Subject: Contract 78-07,
Grass Creek Bridge, Site 7-112,
Highway 2, District 8, Kingston.

FOUNDATION INVESTIGATION REPORT

Proposed Structure at the Crossing
of Hwy. 2 and Grass Creek
Frontenac Co., Twp. of Pittsburgh
District #8, Kingston
W.P. 836-70-05 Site No. 7-112

GRASS CREEK BRIDGE

HALF SECTION OF FRAME

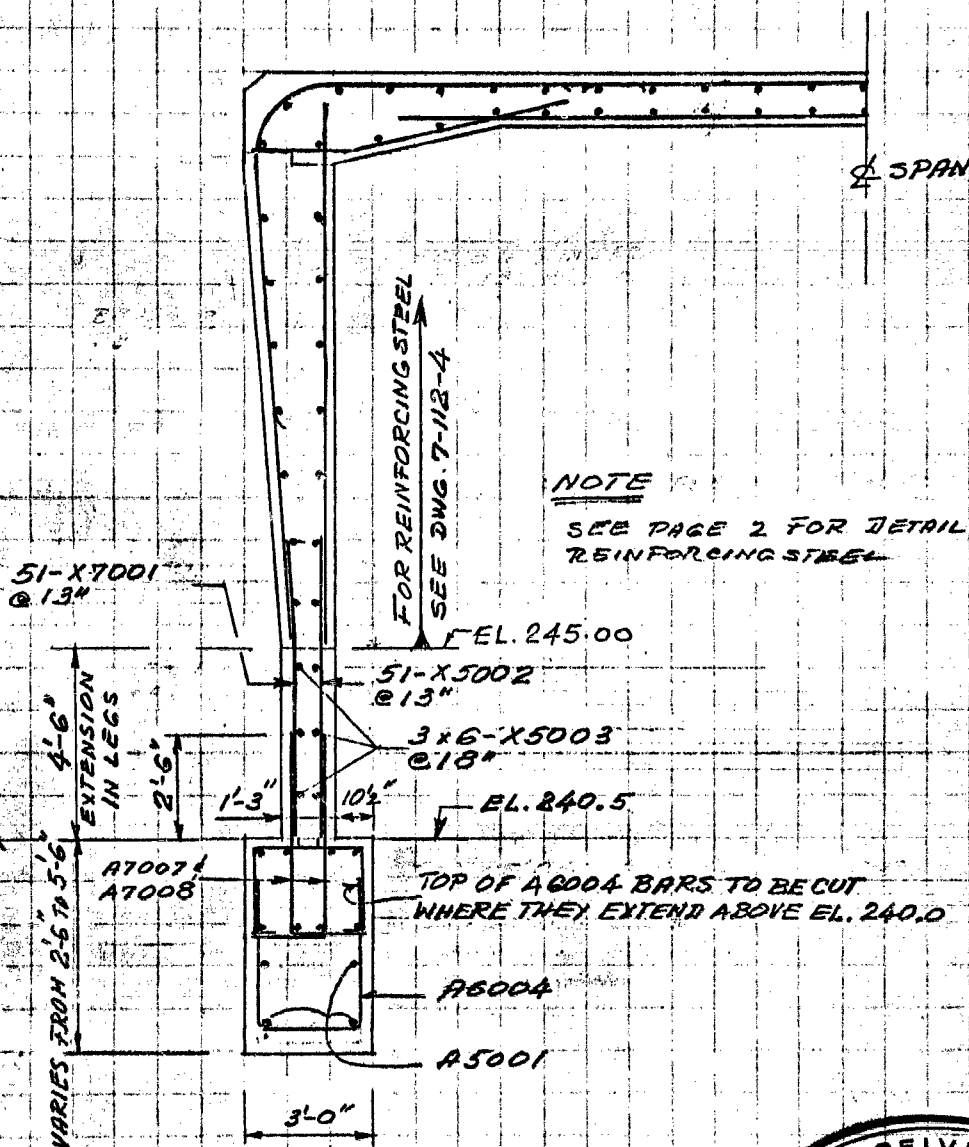
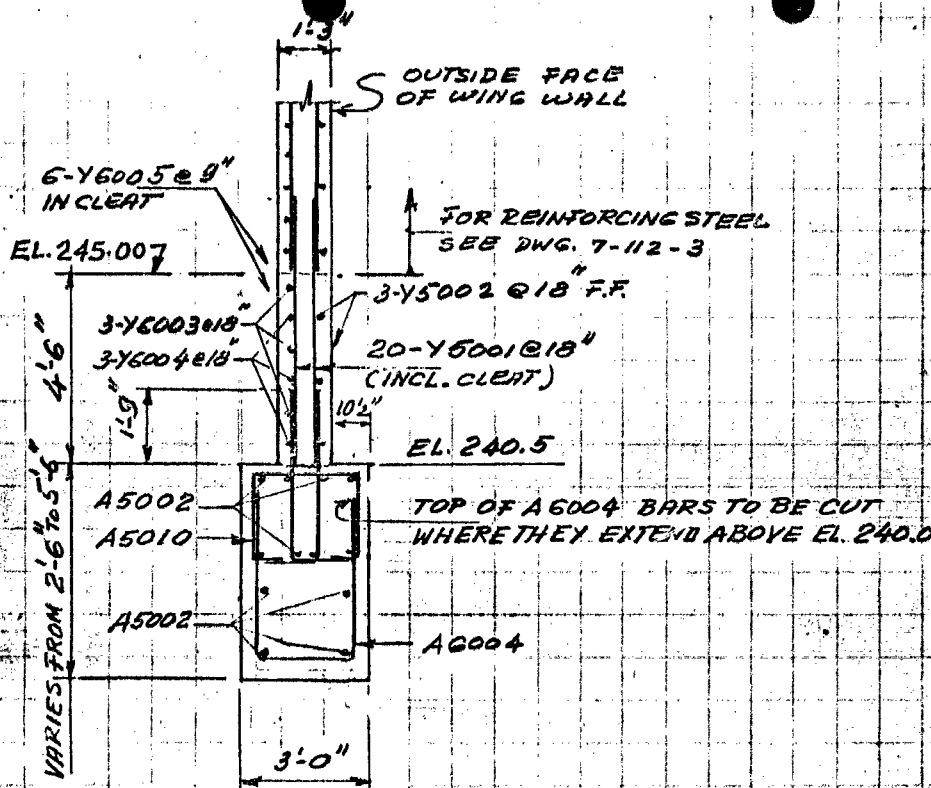
1. Remove boulders at South end of East and West footings down to bedrock.
2. Excavate rock down to El. 238.00 at North end of East footing.
3. Eliminate tremie concrete shown on the drawings since the footing excavation was 'dry'.
4. Eliminate 6" key into bedrock since the bedrock surface was very rough.
5. Lower top of footing elevation to El. 240.50 and vary the depth of 3'-0" wide footing from 2'-6" to 5'-6". Place all reinforcement in footings as shown on drawing 7-112-3 (Sheet 78) except cut legs of bars A6004 when they extend above EL.240.00.
6. Item #5 results in an increase of 4'-6" in the height of the vertical walls of the structure. The attached sketches show the details and the additional concrete and reinforcing steel quantities for the extension.

SEE PAGE 2 FOR DETAIL OF ADDITIONAL REINFORCING STEEL

ADDITIONAL CONCRETE QUANTITIES

CONCRETE IN STRUCTURE 24.5 cu yd.
